Access Compliance Report

Public Rights-of-Way

Intersection ID: 49927	Main Street: ASHBOURNE_HALL_RD	Cross Street: CAMPBELL_HALL_CT	Location: NW
ADA ID: 49AAB85BA341	Ramp Type: Perp	Initial Pass/Fail: Fail	Overall Compliance: No
		Severity Score: 12.5

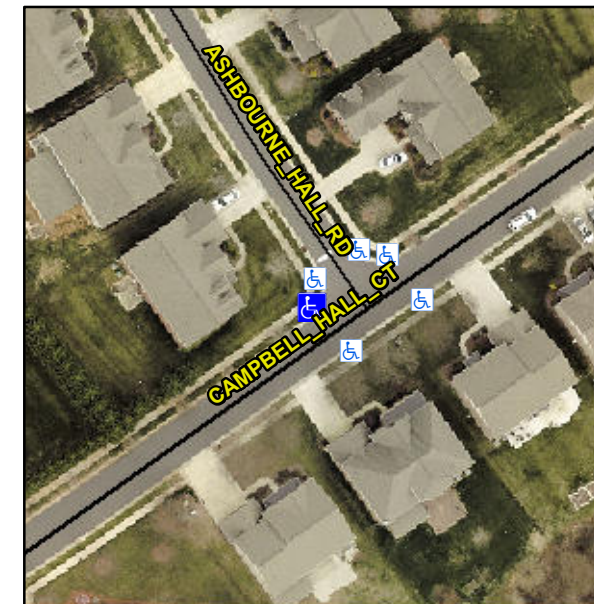
Not Found, R304.2.2

Compliance	Description	Data	Compliance	Description	Data
N/A	Ramp Length (in)	46.0	No	Ramp Slope (%)	11.0
Yes	Ramp Width (in)	48.0	Yes	Ramp XSlope (%)	0.9
N/A	Flare Type LT	N/A	N/A	Flare Type RT	N/A
N/A	Flare Slope LT (%)	N/A	N/A	Flare Slope RT (%)	N/A
N/A	Flare Traversable LT?	N/A	N/A	Flare Traversable RT?	N/A
N/A	Landing Length (in)	N/A	N/A	DWS Provided?	N/A
N/A	Landing Width (in)	N/A	N/A	DWS Contrast?	N/A
N/A	Landing Slope (%)	N/A	N/A	DWS Length (in)	N/A
N/A	Landing X Slope (%)	N/A	N/A	DWS Full Width?	N/A
N/A	Landing Curb? (Y/N)	N/A	N/A	DWS Offset (in)	N/A
N/A	Shared Landing?	N/A			
N/A	Gutter Ponding?	N/A	N/A	Gutter Slope (%)	N/A
N/A	Gutter Lip Ht (in)	N/A	N/A	Gutter X Slope (%)	N/A
N/A	Painted X Walk1?	No	N/A	Painted X Walk2?	N/A
	X Walk 1 Direction	To SE		X Walk 2 Direction	N/A
N/A	X Walk 1 Width (in)	N/A	N/A	X Walk 2 Width (in)	N/A
	X Walk 1 Slope (%)	0.5		X Walk 2 Slope (%)	N/A
	X Walk 1 X Slope (%)	1.8		X Walk 2 X Slope (%)	N/A

Remove & Replace Entire Ramp.
